**Tobacco — Determination of the  
content of total alkaloids as nicotine  
— Continuous-flow analysis method**

**AMENDMENT 2**

Reference number  
ISO 15152:2003/Amd.2:2018(E)

**Figure B.1 — Flow diagram of continuous-flow analyser**

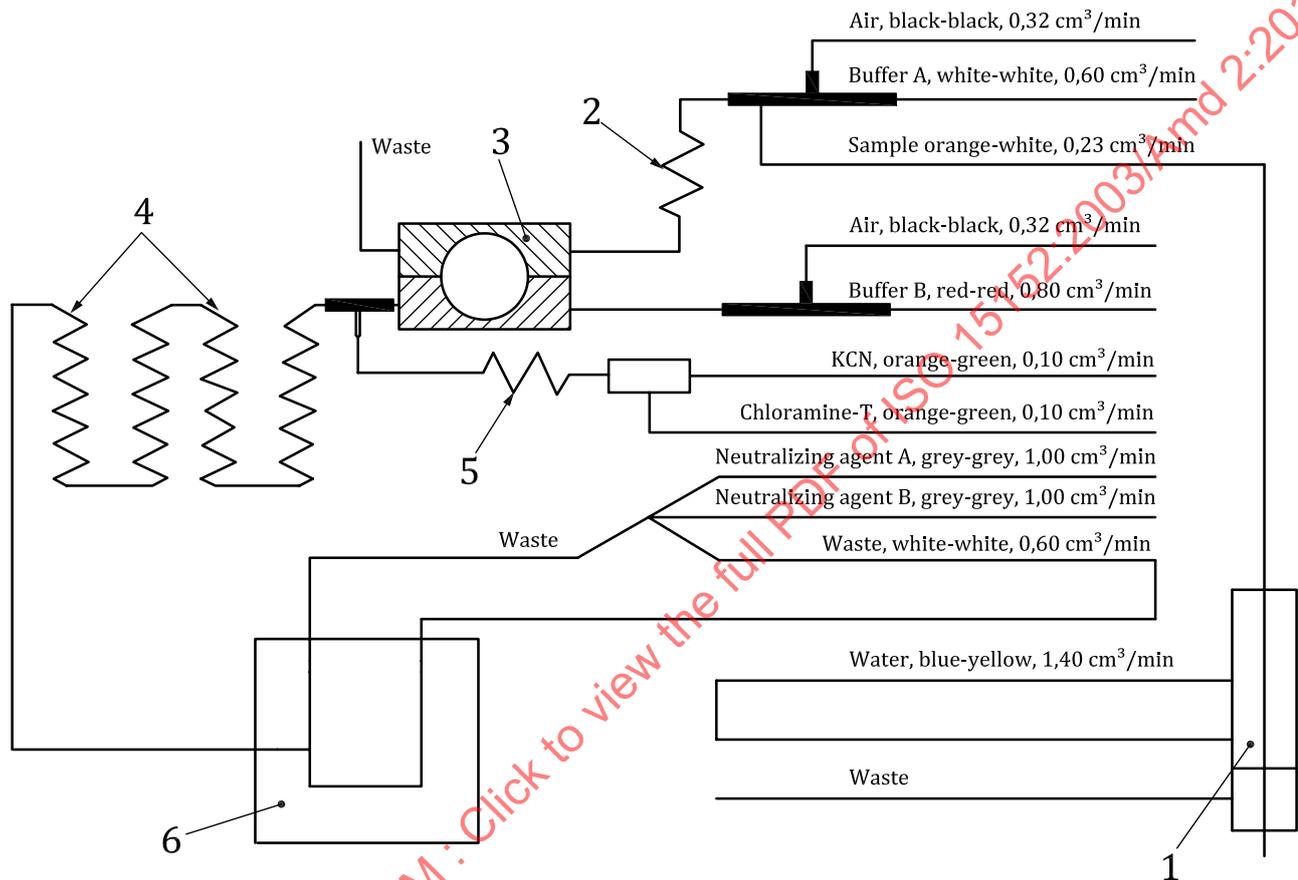
Replace Annex B with the following:

NOTE 2 Neutralization solution C (see 5.7) can be used instead of a mix of neutralization solutions A and B.
